DISD Leila P Cowart Elementary School
DISD James Bowie Elementary School
COMM. NO. 1287 and 1288
ORG 130 and 112
CSP J130_P1000_1 and J112_P1000_1 (207858)
January 28, 2025

ADDENDUM NO. 01
TO THE DRAWINGS AND PROJECT MANUAL

1 FOODSERVICE VENTILATION AND FLOOR DEPRESSION REQUIREMENTS PLAN
 QF131 SCALE: 1/4" = 1'-0"

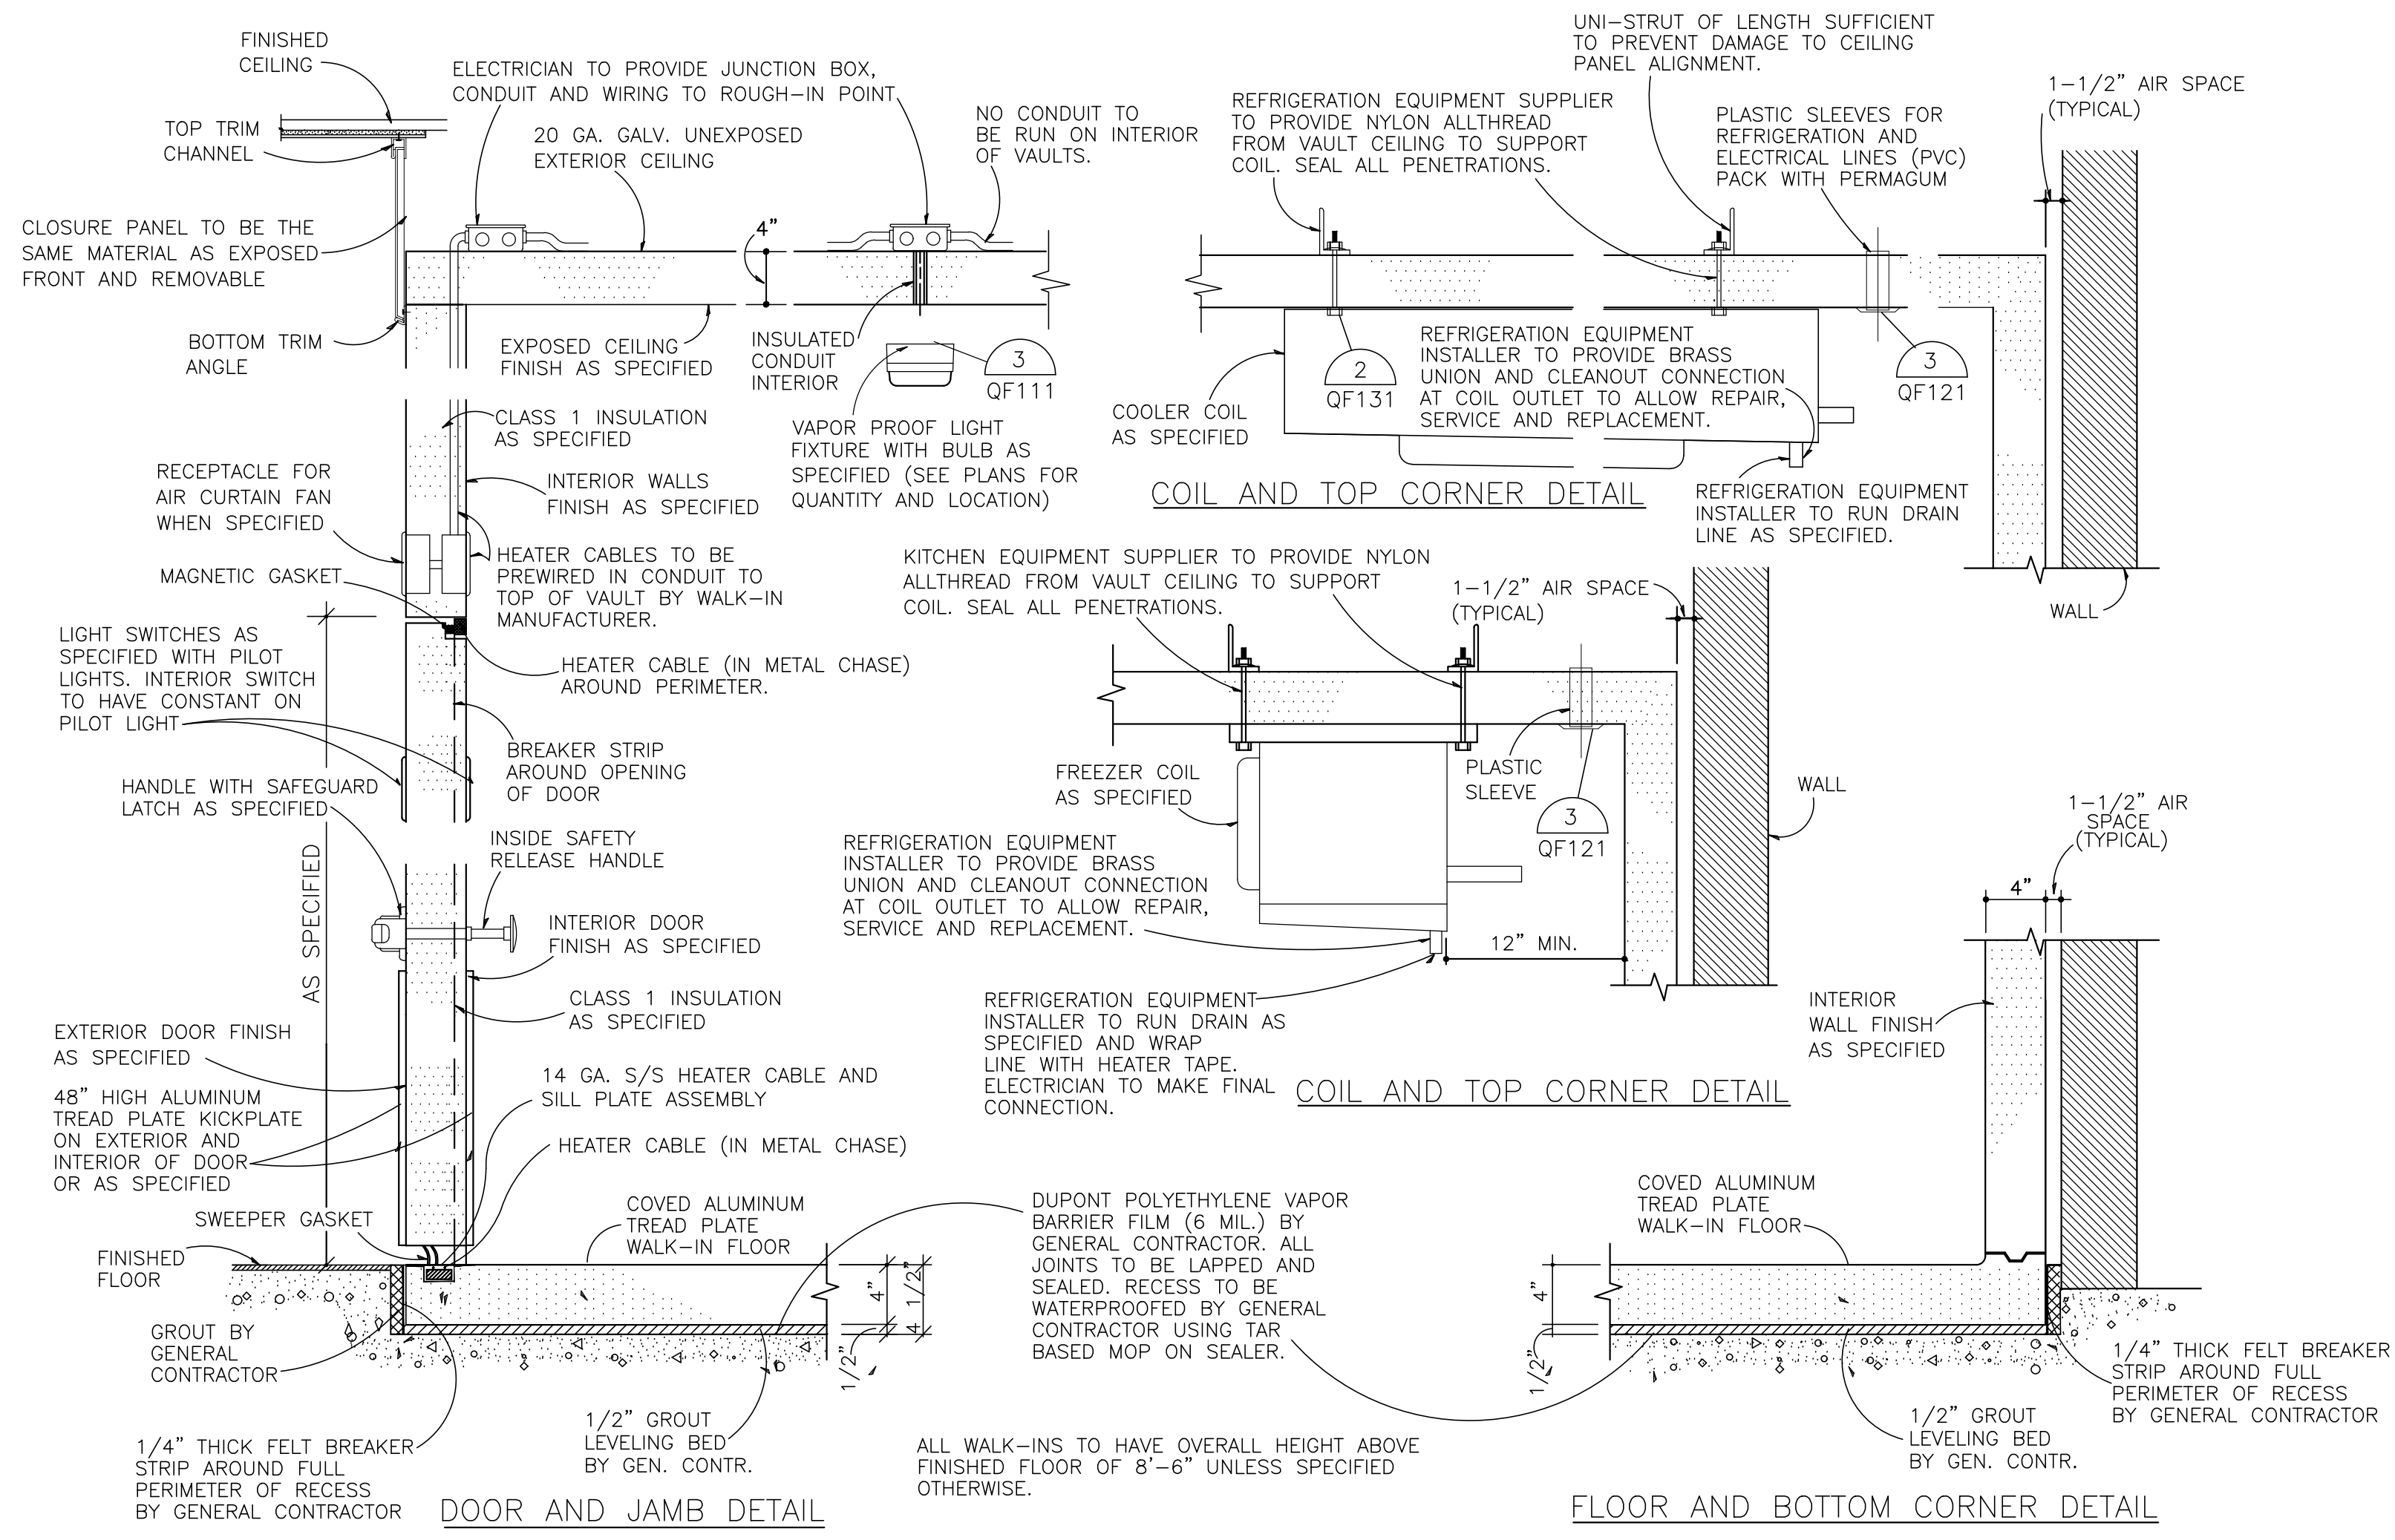
- 1.01 Combined Specifications: "Please provide the available existing swing space"
RESPONSE: None is available. See attached replacement specification section 01 52 14 Temporary Facilities For Students.
- 1.02 Leila Cowart: "Please provide detail for sidewalk replacement"
RESPONSE: Detail added, see attached sheet 1.01.
- 1.03 Leila Cowart: "Please move note so it can be read"
RESPONSE: Note moved, see attached sheet 2.17A.
- 1.04 James Bowie: "Signage Schedule is incomplete. Can we get a complete schedule?"
RESPONSE: Signage Schedule has been filled-in. See attached sheets 4.04A and 4.04B.
- 1.05 James Bowie: "Note is hard to read due to background. Can you move note?"
Response: Note moved, see attached sheets QF121 and QF131.
